Re: 1738 Tilghman Street – LMA 2016-00009

Pursuant to your ordinances and requirements, we are submitting this letter as our written response to the comments for the proposed project.

LCA (Lehigh County Authority) offers the following comments on the proposed public water and sewer service connection plan, dated July 26, 2016, last revised October 23, 2016, for 1738 West Tilghman Street Allentown, Pennsylvania, as shown on the plan titled "Final Plan for Burger King, Allentown, PA".

BIOFILTRATION/BIORETENTION POND #2

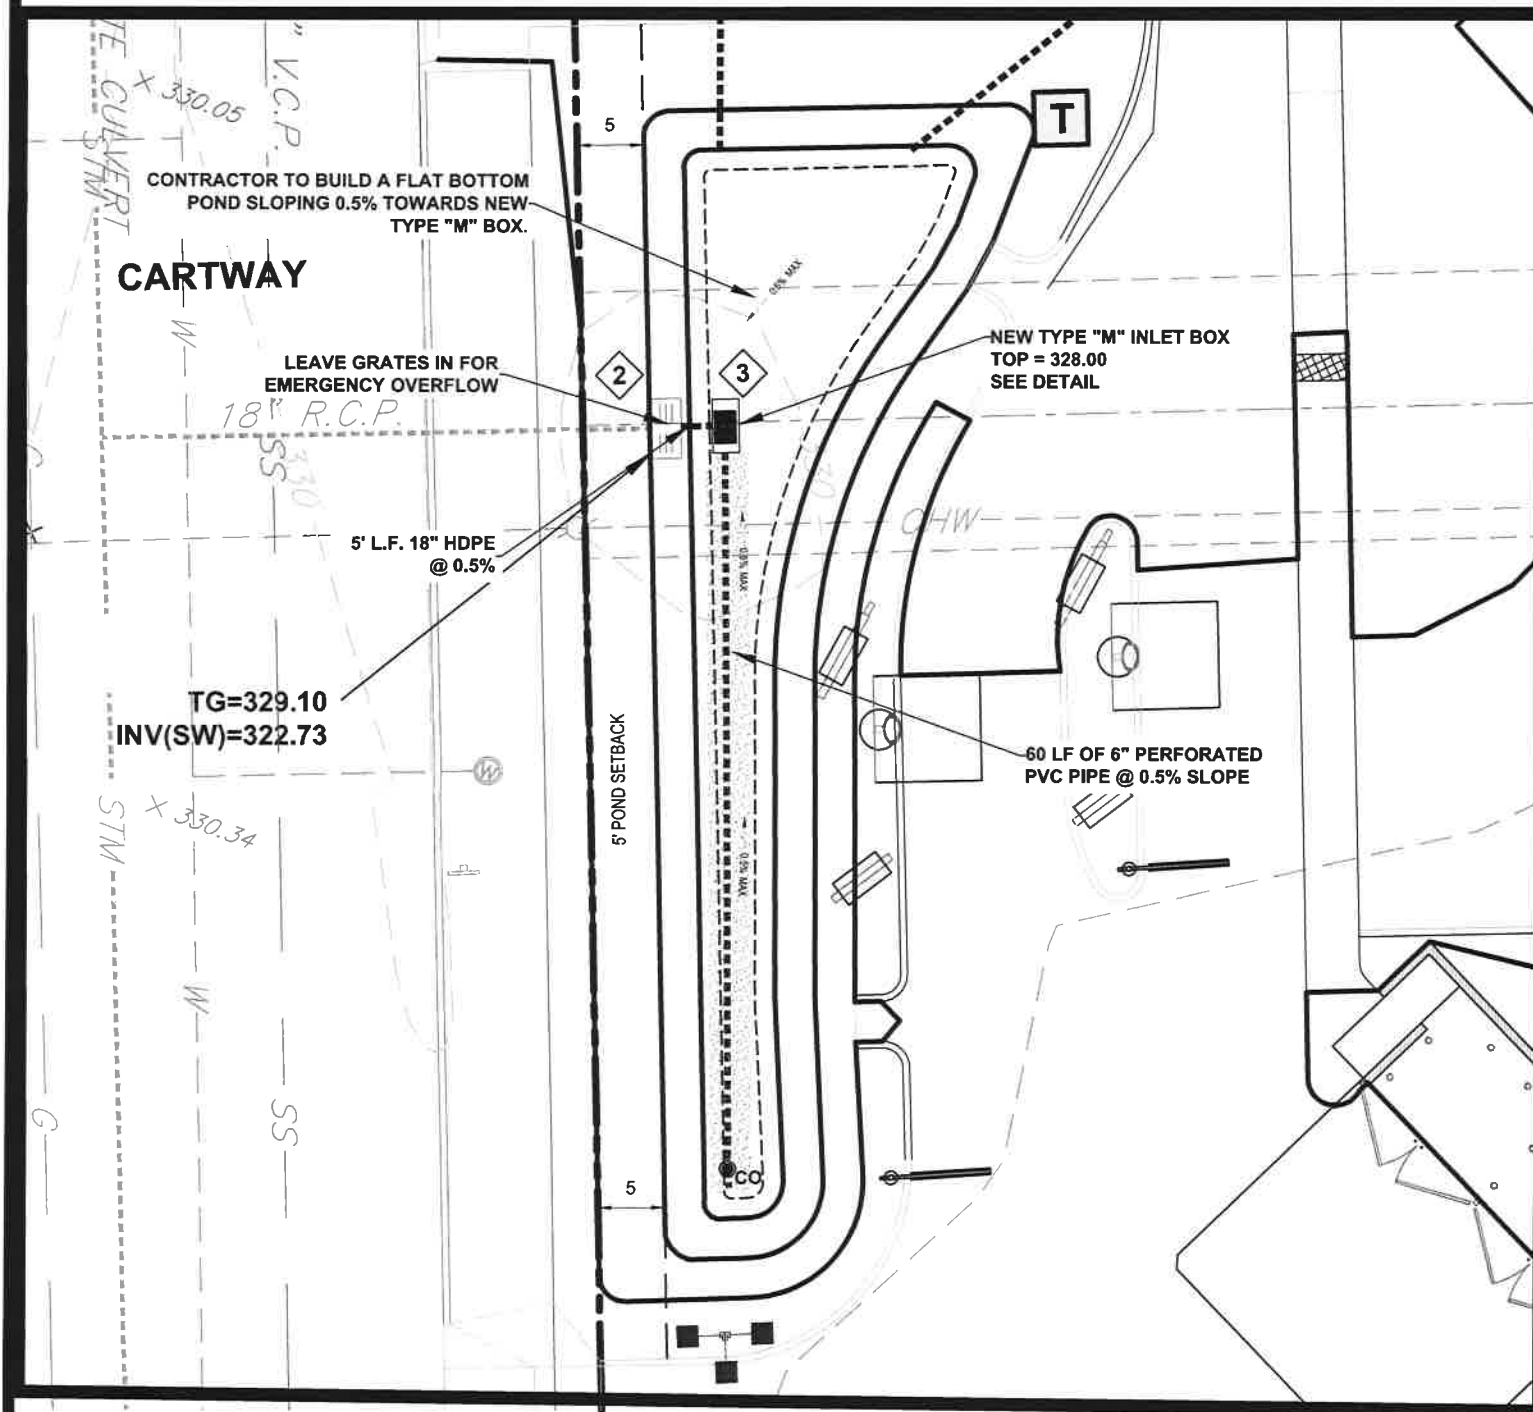
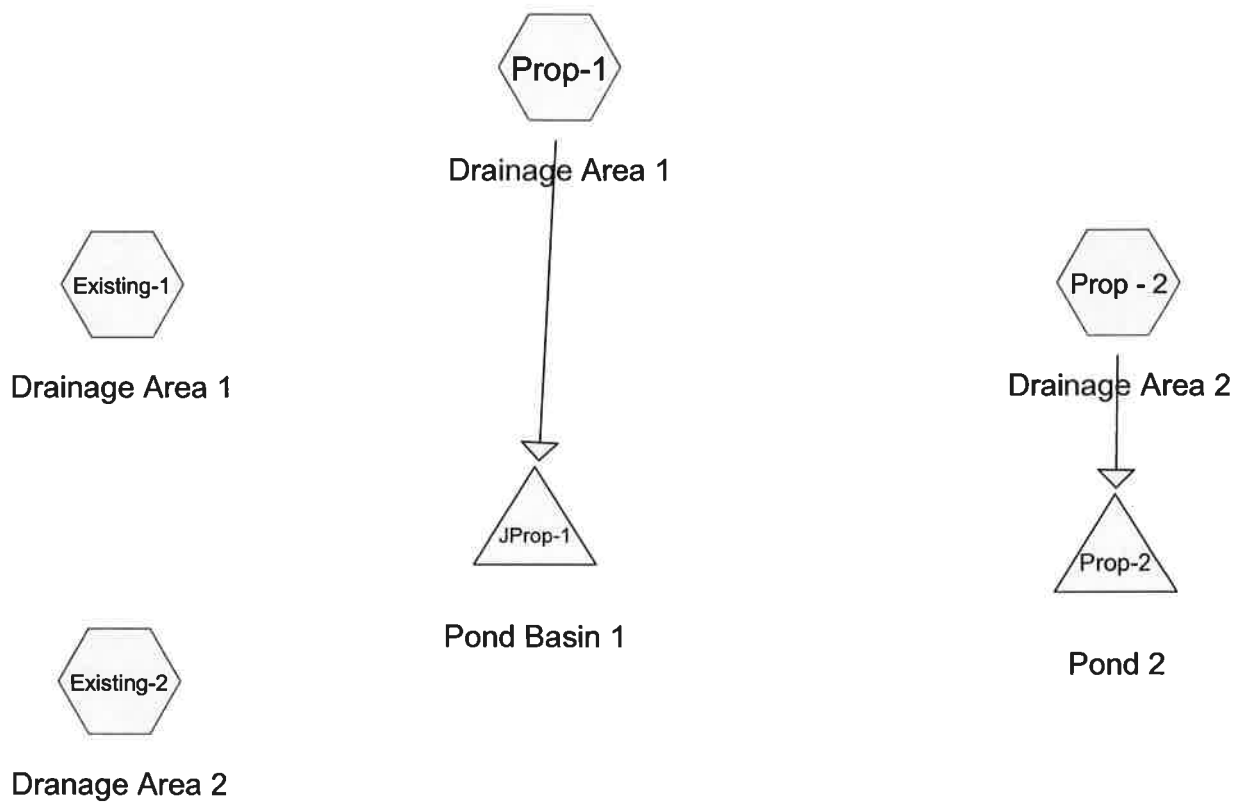
8. With respect to the stormwater calculations and other corresponding PCSM plans, the following items shall be addressed.
 - a. Per item #6.4.4 of Table A-4 – indicate on the plans where the porous pavement within the Infiltration bed is being placed.

- b. Per the Infiltration Trench Outlet box trench details
 - i. The plan view TG does not match the detail or chart elevation.
 - ii. Elaborate as to why the height of the 25 year storm is higher than the calculated 100 year frequency storm event.
 - iii. Provide a detail of the WQ device for the downstream end of the proposed 8" perforated PVC conduit.

Was incorrectly marked on the sheet, corrected.

All three of these items have been corrected on Sheet C4.0 and C4.1
